THE CITY OF SAN DIEGO

ENVIRONMENTAL IMPACT REPORT

Project No. 240716
SCH No. 2015081031

CARROLL CANYON MIXED-USE PROJECT DRAFT EIR COMMENT LETTERS

Figure 2-5. Surrounding Land Uses

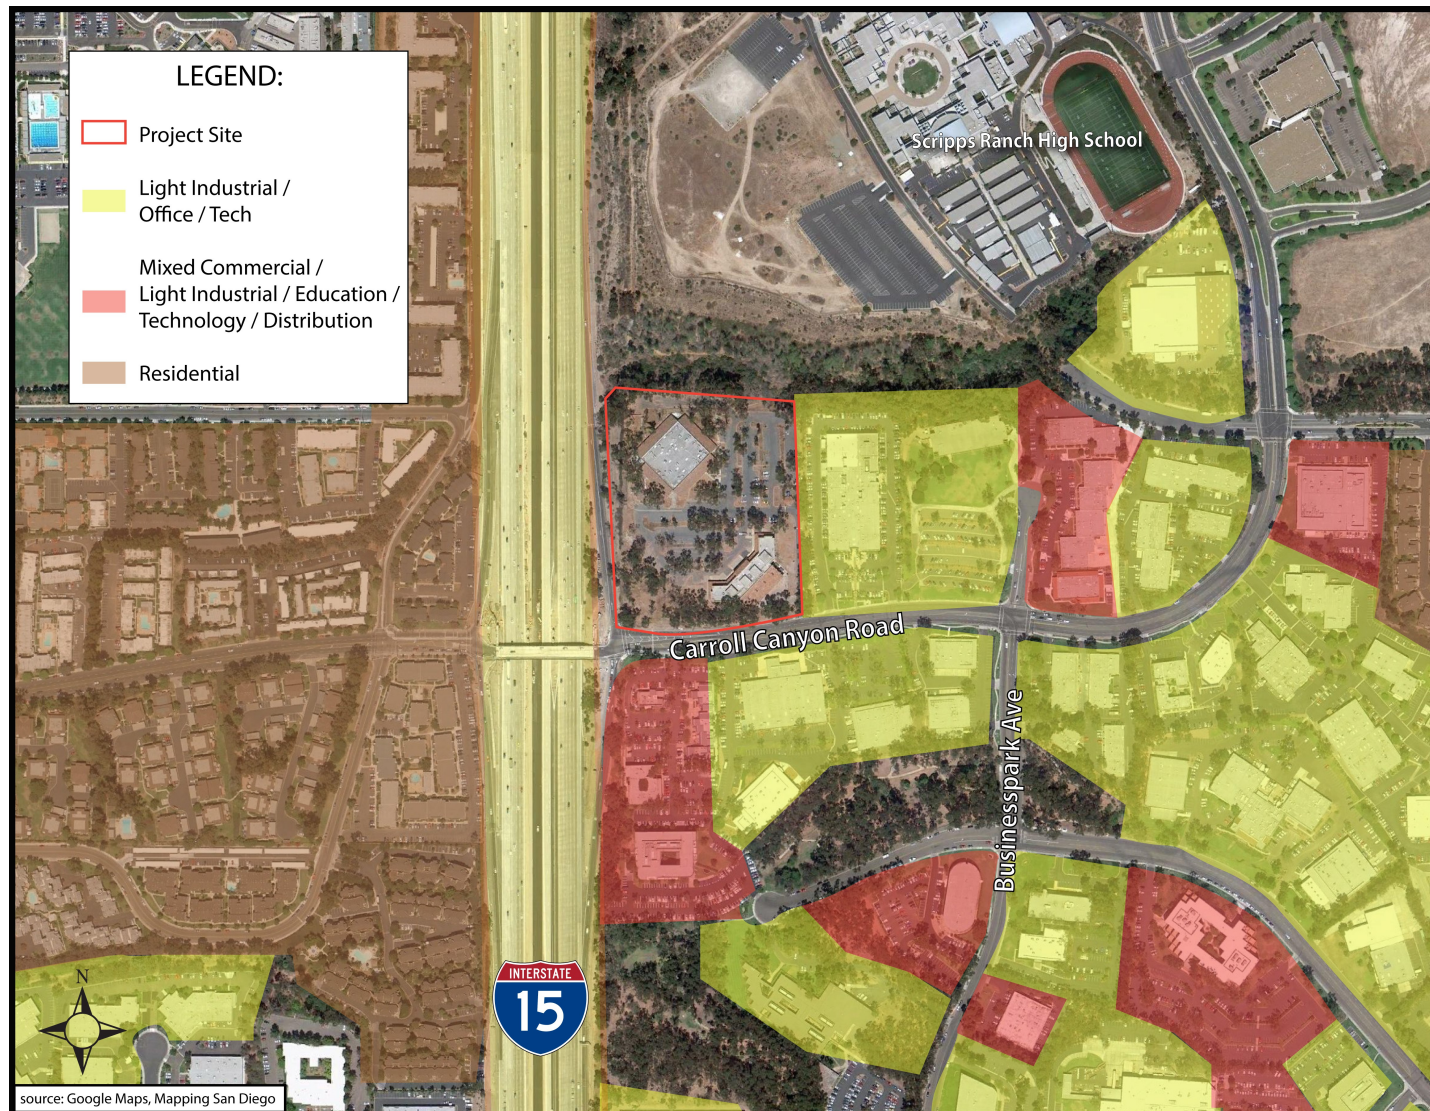
| | COMMENT | RESPONSE |
|-------------|--|---|
| H-25 | <p>The project objectives are misleading to the reader. Objective 3 strives to “Allow for retail uses currently limited in availability in the surrounding market area” when the surrounding area is shown in Figure 2-5 to already have a diverse mix of commercial and industrial zoning.</p> | <p>H-26 Project Objective 5 states, “In keeping with the City of Villages and Smart Growth policies, provide for efficient use of the project site with a viable mix of residential and commercial uses as an in-fill development of an underutilized site within an urban area where amenities and services are available and easily accessed via alternative modes of travel, including transit, bike, and pedestrian.” Objective 5 also identifies bike and pedestrian access as alternative modes of transit, in addition to mass transit. The project provides this accessibility. See Response No. F-2.</p> |

Figure 3-8. Carroll Canyon Mixed-Use Project Site Plan

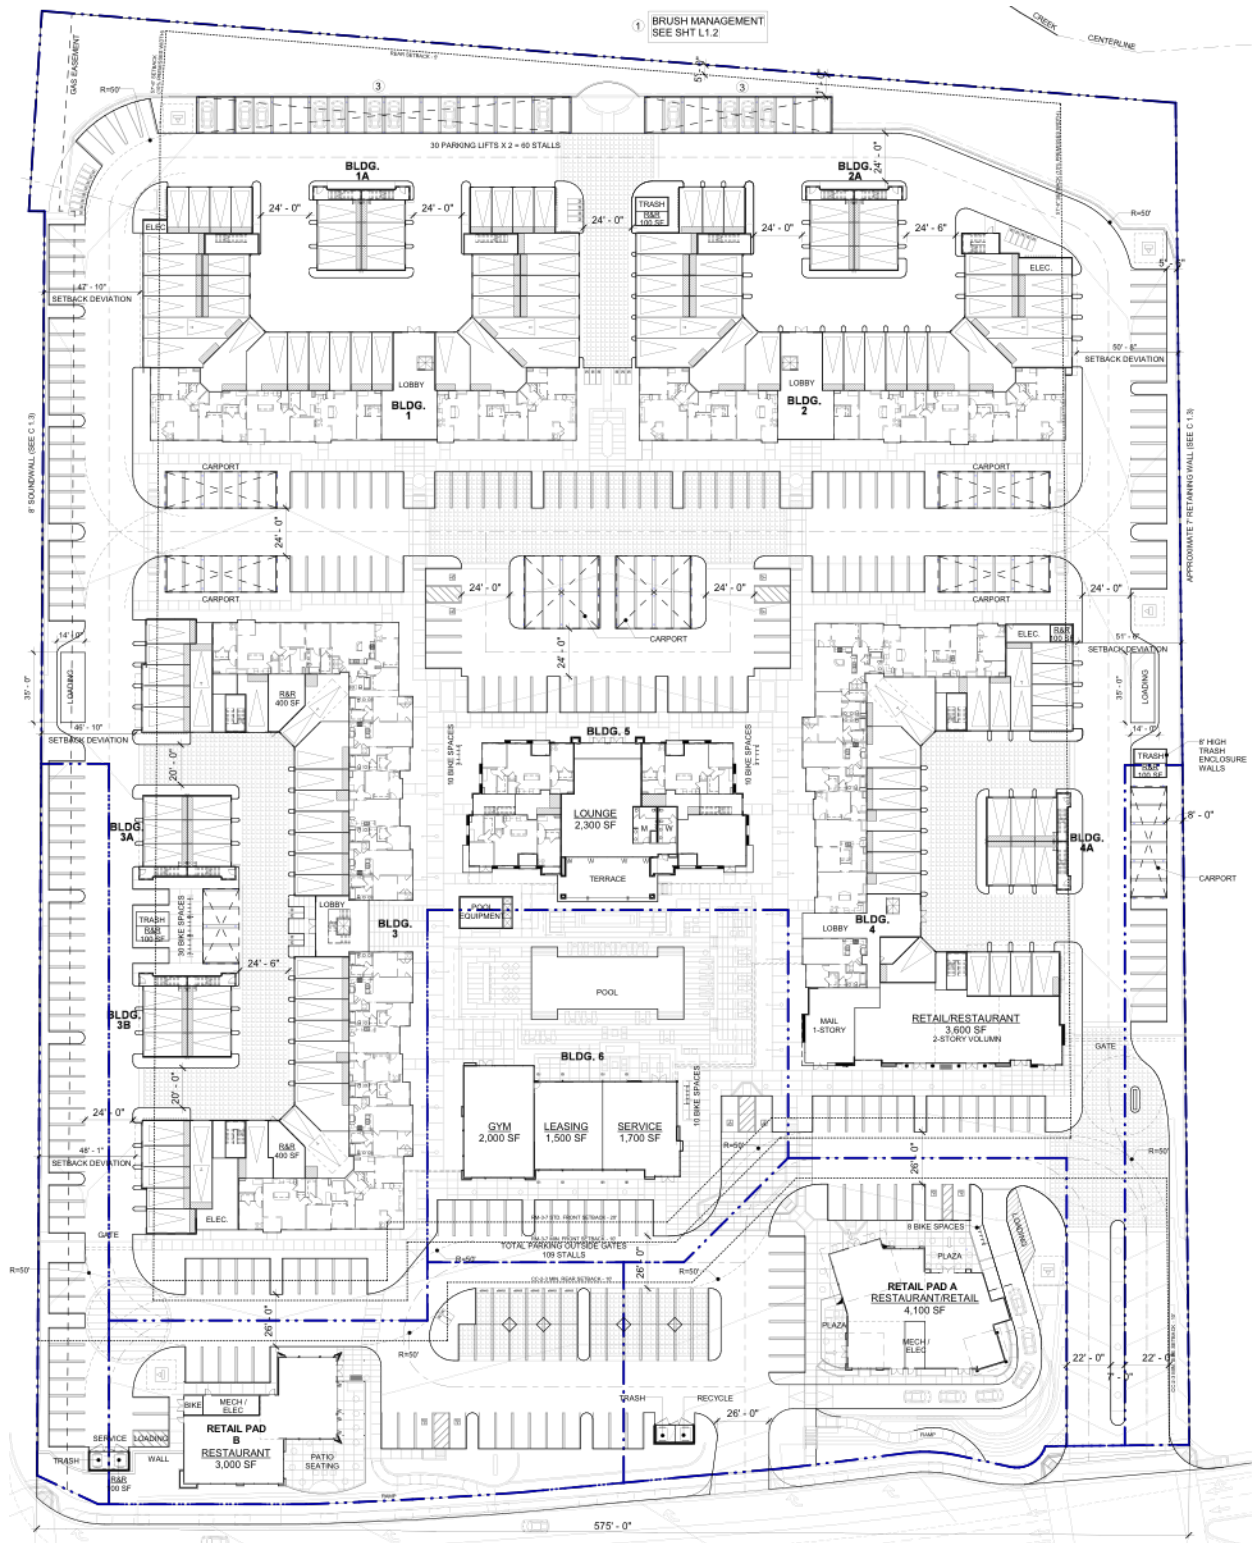
| COMMENT | | RESPONSE |
|--|---|---|
| <p style="text-align: right;">Page 3 of 8</p> <p>3.0 Project Description</p> <p><i>Figure 3.8 - Site Plan and Table 3-2 Proposed Deviations</i></p> | | |
| H-5 | The site plan depicts the property as six separate lots; however, the lots are not numbered on the site plan even though they are referred to by number later in Table 3-2 Project Deviations. | H-5 Lots are clearly shown in Figure 3-7, <i>Project Grading Plan</i> , which immediately precedes Table 3-2, <i>Project Deviations</i> , as well as within the Project Exhibits available for review at the City of San Diego. |
| H-6 | Various setback deviations are requested with some labeled on the site plan, except for the 8'0" proposed setback on the east side of the property (uncertain which lot that is because they are not numbered on the site plan). There is also a proposed height deviation to increase the allowable | H-6 All proposed setback deviations are labeled on Figure 3-8, <i>Site Plan</i> , including the 8'0" proposed setback on the east side of the property. |
